# **ALBERTA ENERGY AND UTILITIES BOARD**

## **CRESTAR ENERGY INC. APPLICATIONS TO CONSTRUCT AND OPERATE SOUR GAS BATTERIES AND PIPELINES VULCAN FIELD**

**Decision 99-13  
Applications No. 1033453 and 1037084**

VULCAN FIELD  
 Attachment 3  
 Applications No. 1033453 & 1037084  
 Crestar Energy Inc.

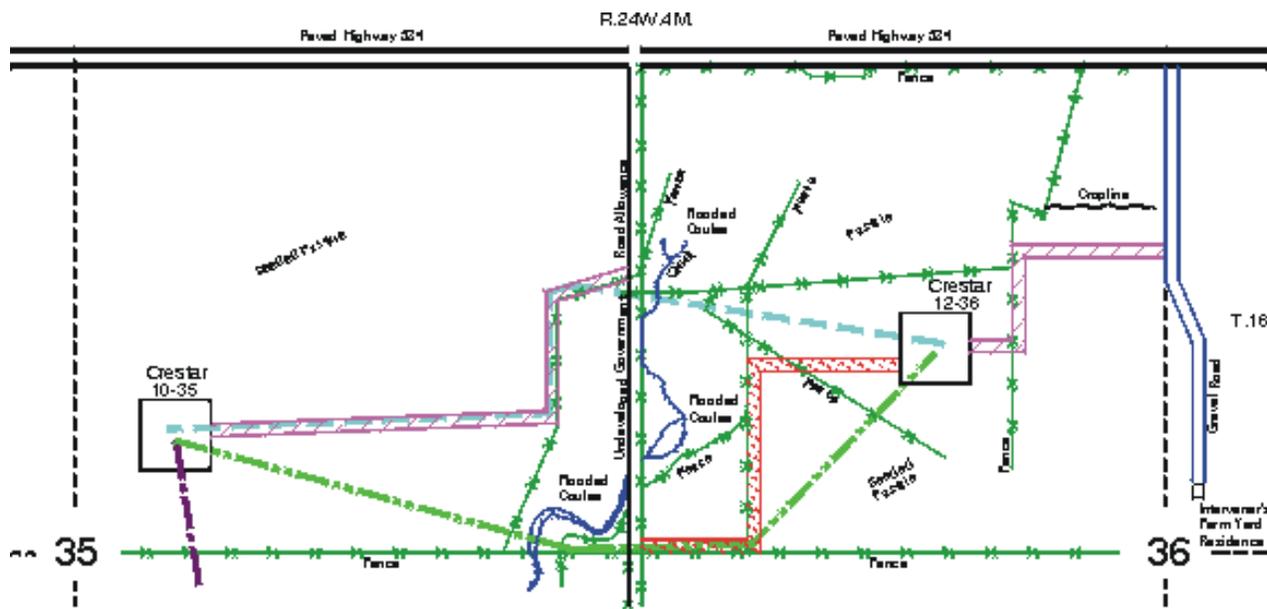
The Board has reviewed the proposed pipeline routing Options 1 and 2, Applications No. 1033453 and 1037084 respectively, and has considered the evidence of both parties. The applicant prefers Option 2, because it would place the pipeline within the existing 10-35 facility access road right of way and create less land disturbance. The interveners prefer Option 1 because they believe that it would involve less disturbance to their rotational pasturing system, avoid location of a pipeline within a waterway historically subject to major flooding, and cause

less disturbance and erosion to the creek bed. Additionally, the interveners stated that their preferred pipeline and access road routes take into careful account a justifiable need to maintain the value of their property by maximizing and preserving existing useable farming acreage. However, the Board notes, that the applicant was willing to mitigate these concerns by boring the pipeline under the creek and coulee, and was willing to reconstruct the rotational fencing and gate system, if necessary. The Board additionally understands that the landowner of Section 35, also prefers Option 2. Option 2 is a compromise agreement reached between the applicant and the landowner of Section 35 who will incur additional surface equipment at the 10-35 facility as a result of the proposed relocation of installations from the 12-36 facility.

There was insufficient evidence presented for the Board to determine if one pipeline routing option was economically more viable than the other. The Board believes that both options provide similar technical advantages and disadvantages and either could be operated to meet the Board's regulatory requirements. Additionally, the applicant has committed to implement a pipeline corrosion mitigation and monitoring program for either option, based on a two week schedule and adjusted as necessary in the future. However, considering the concerns of all parties, the Board believes that there are fewer land-use impacts and surface disturbances with Option 2, since it would be the most direct route, involves the least amount of pipeline length and could utilize directional drilling technology.

The Alberta Energy and Utilities Board (the Board) has carefully considered the evidence received and approves Application No. 1037084. This approval is subject to Crestar Energy Inc. (the applicant) meeting all regulatory requirements and the conditions as set out in Attachment 1. Accordingly, Application No. 1033453 is denied.

At the request of the landowner of Section 35, the applicant submitted an amendment to Application No. 1037084 on 12 April 1999, placing the pipeline within the existing 10-35 facility access road.
